**STAFF REPORT**  
**KETCHUM PLANNING AND ZONING COMMISSION**  
**REGULAR MEETING OF MARCH 28, 2023**

**PROJECT:** Leadville Trading

**APPLICATION TYPE:** Final Design Review and Conditional Use Permit (CUP)

**REQUEST:** Design Review application for the development of a new 6,039 square foot two story commercial development and Conditional Use Permit for three on-site parking spaces.

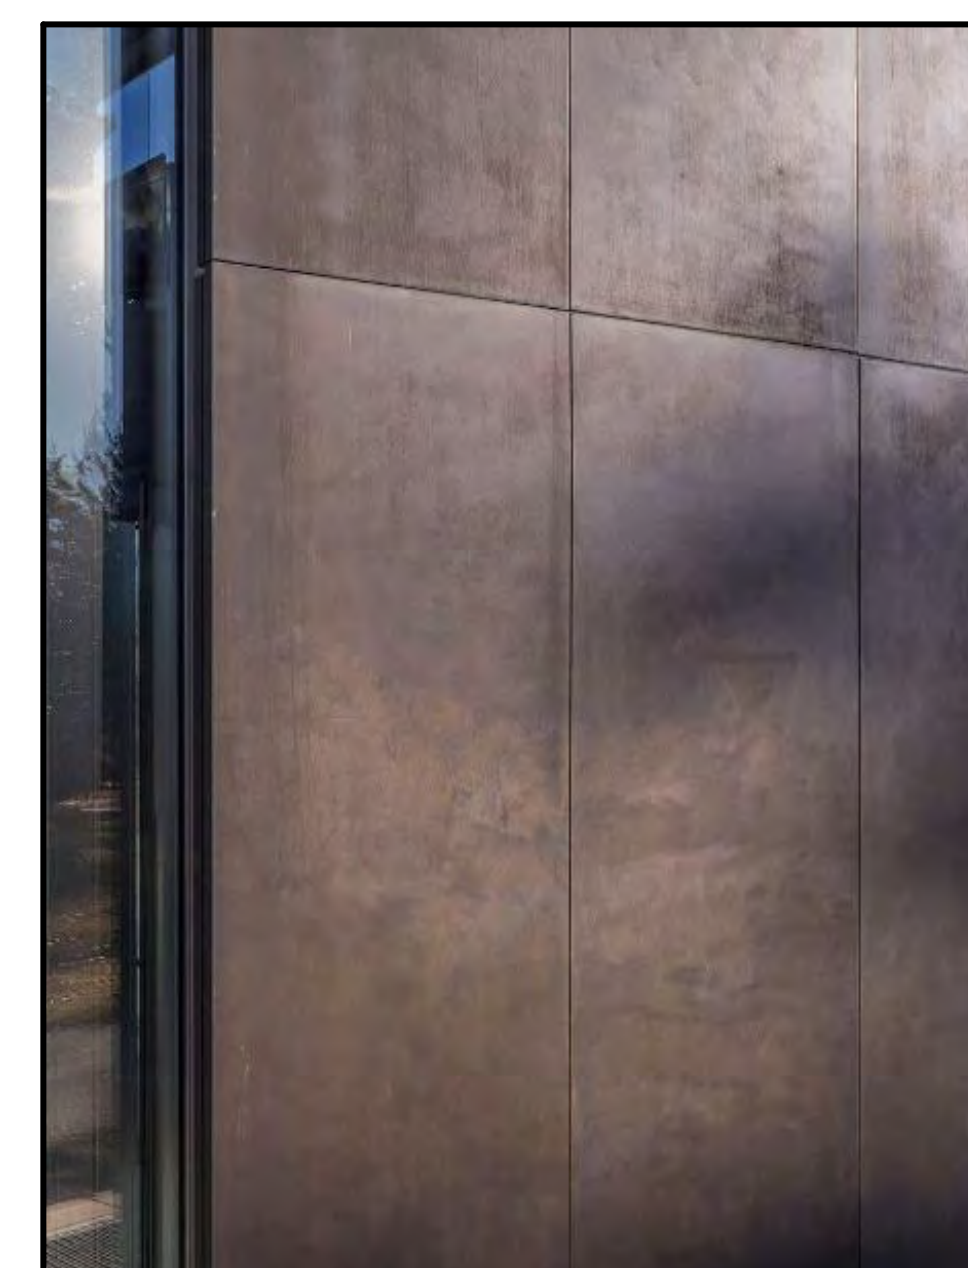
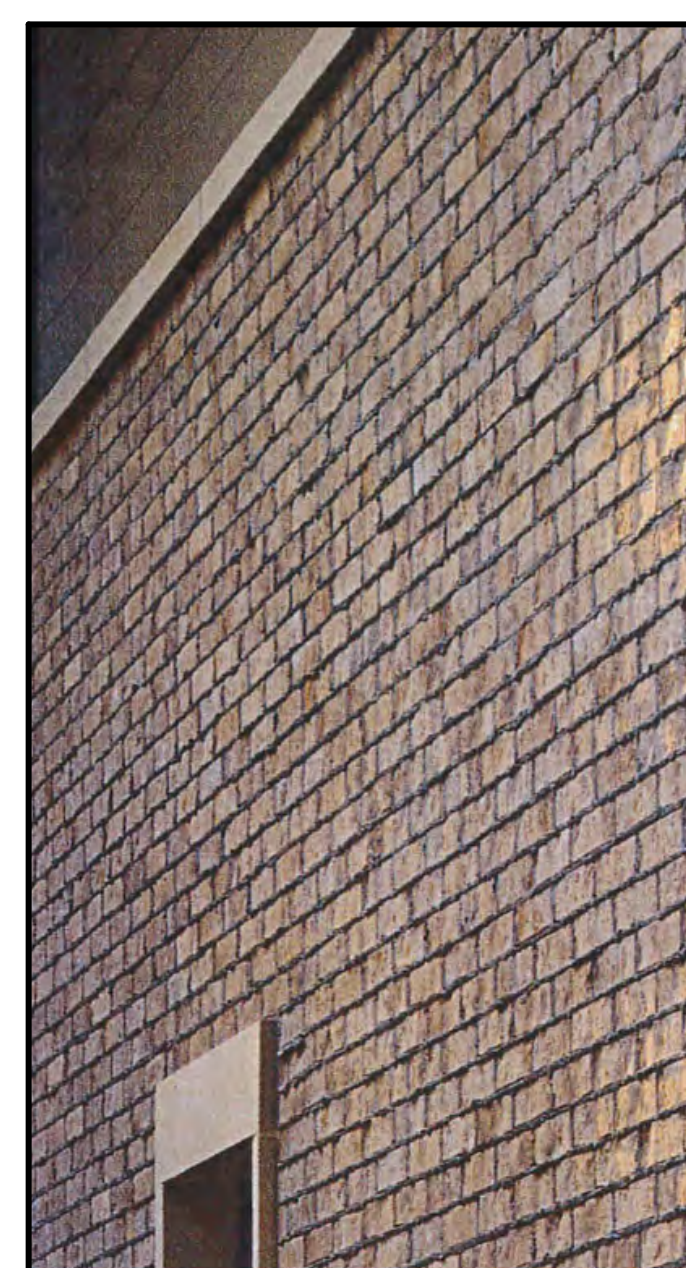
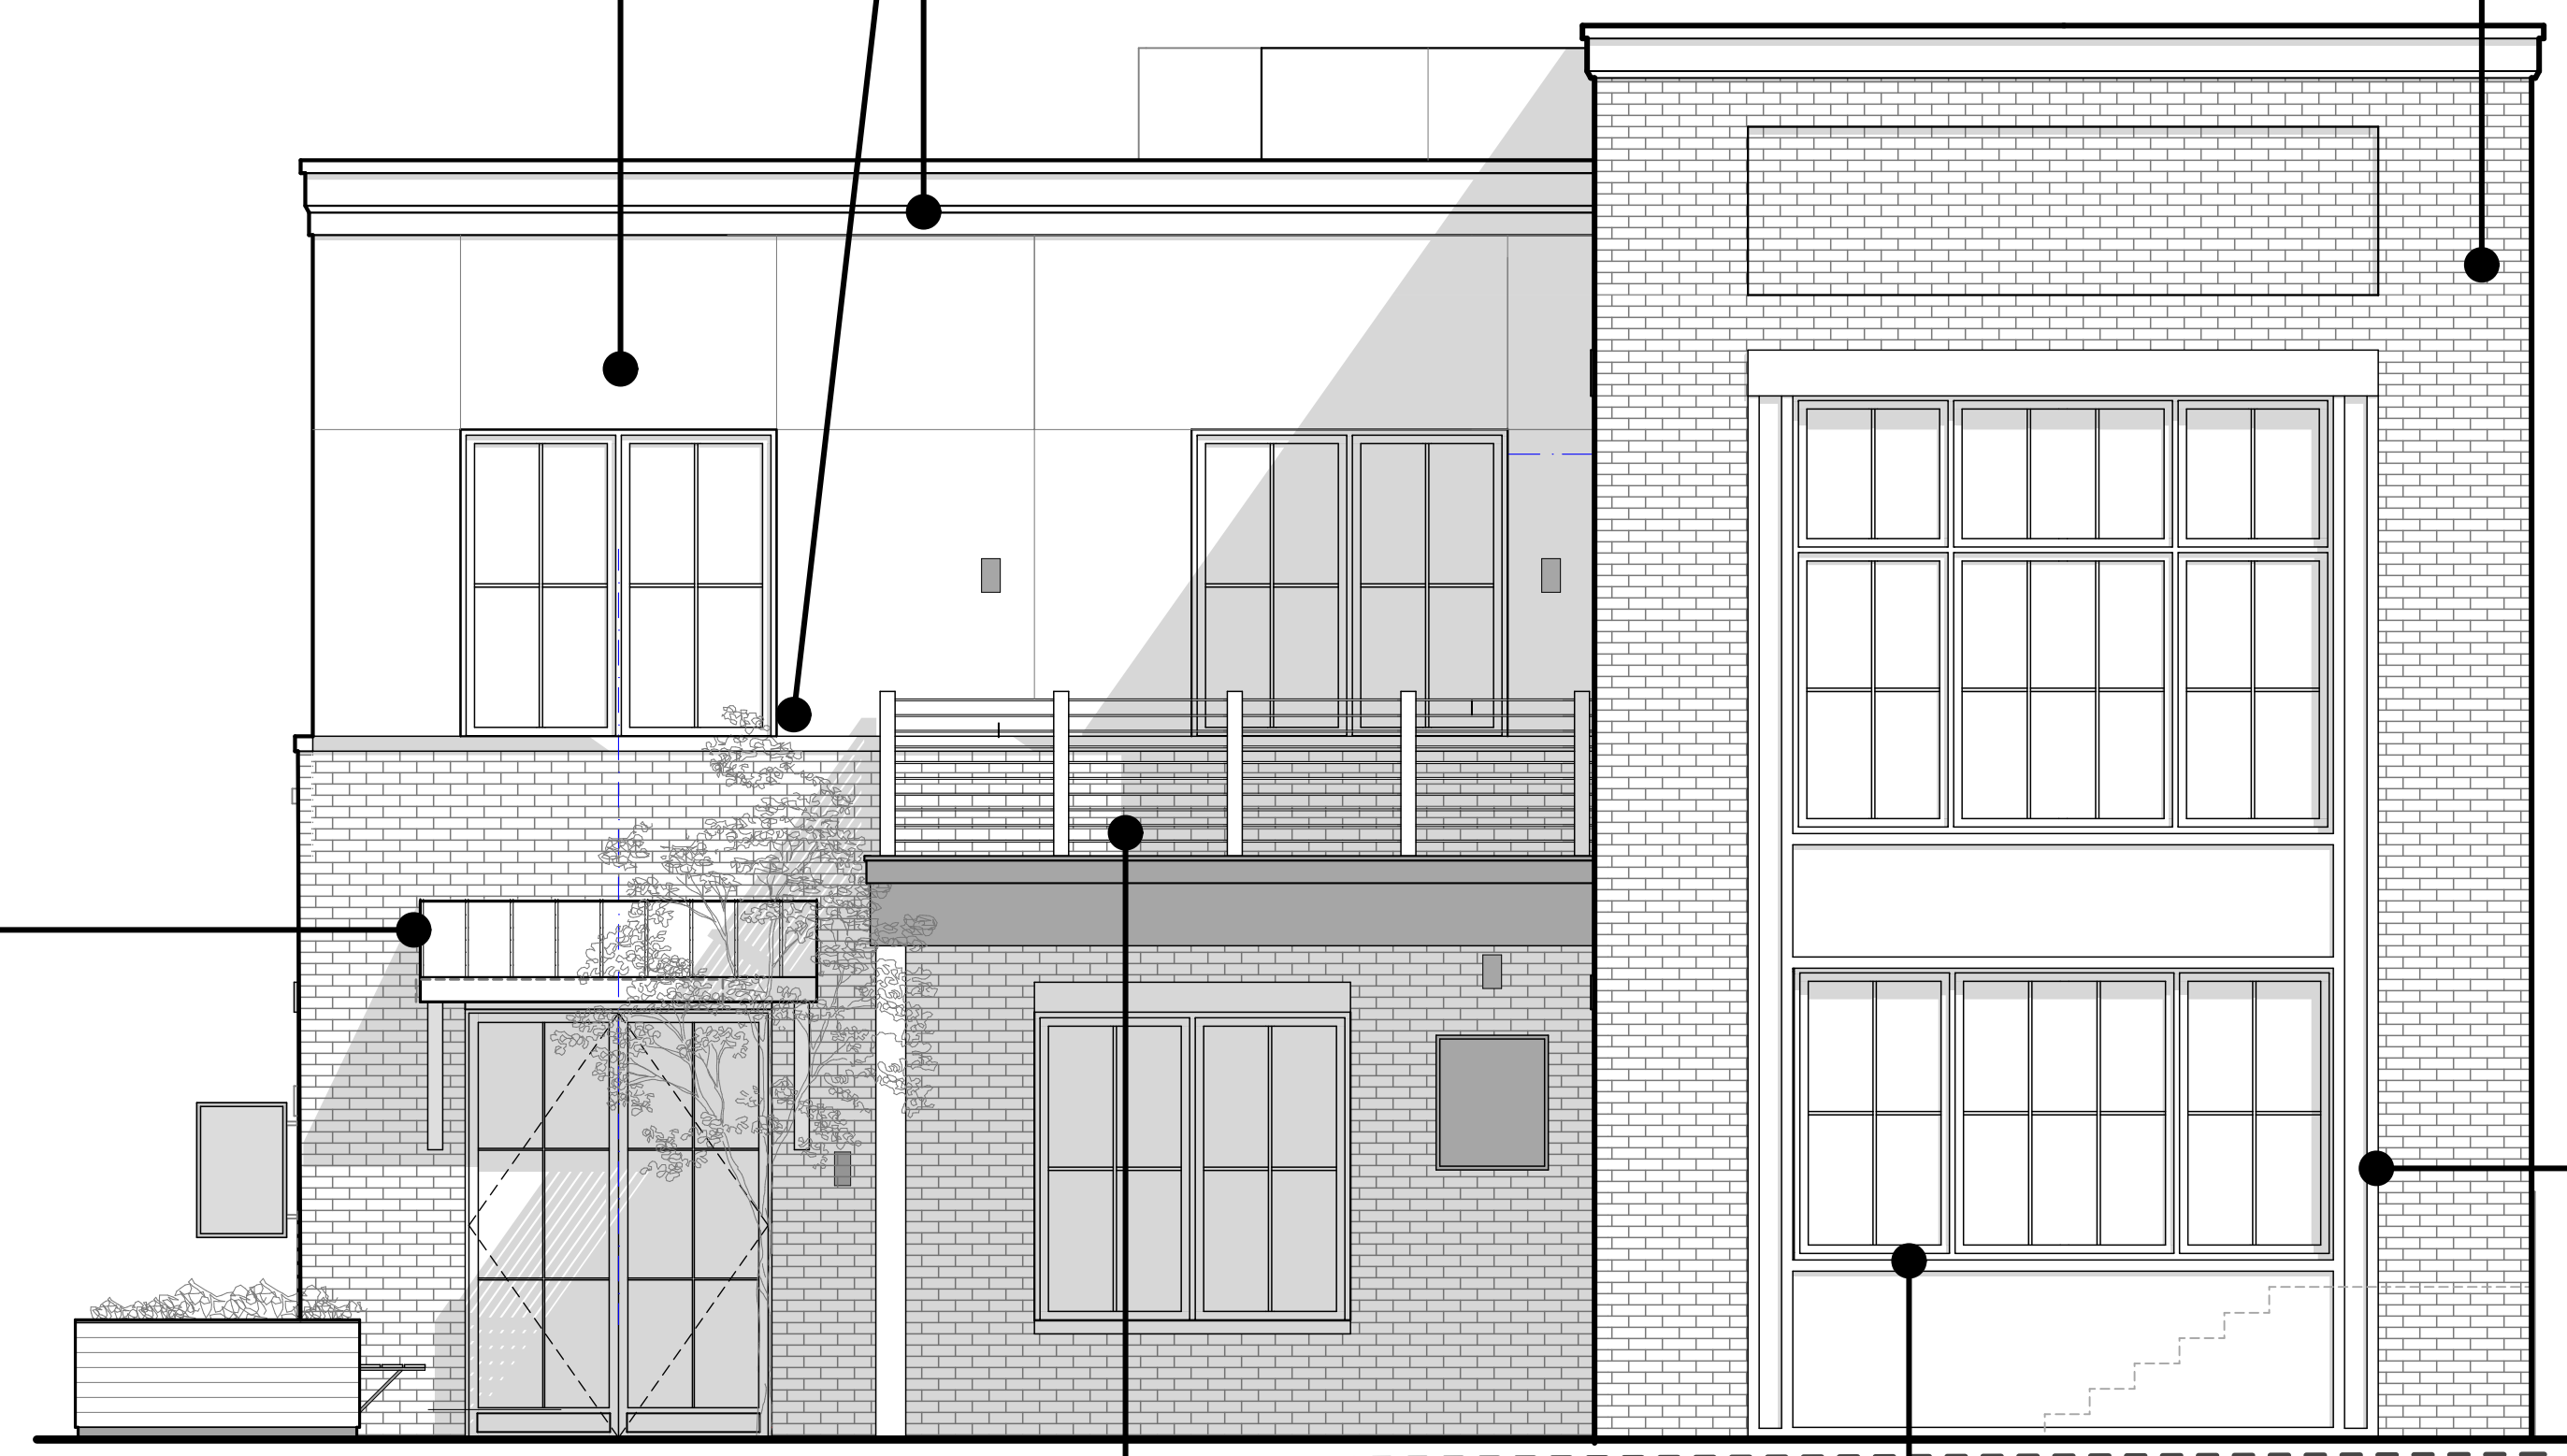
17.96.060.F.3 – Architectural	Conformance
<i>There shall be continuity of materials, colors and signing within the project.</i>	YES
<b>Finding:</b> As shown on Sheet A3.3, the project proposes a consistent set of materials including brick, bronze metal panels, and dark trim for windows and doors. The project also proposes dark metal trim for the cantilevered deck on the Leadville side of the building. The signage for the project is minimal and does not deter from the architectural characteristics of the building. Signage is primarily wall mounted signage on both Leadville and 2 <sup>nd</sup> Street with one blade sign proposed on the 2 <sup>nd</sup> Street side of the building for the restaurant.
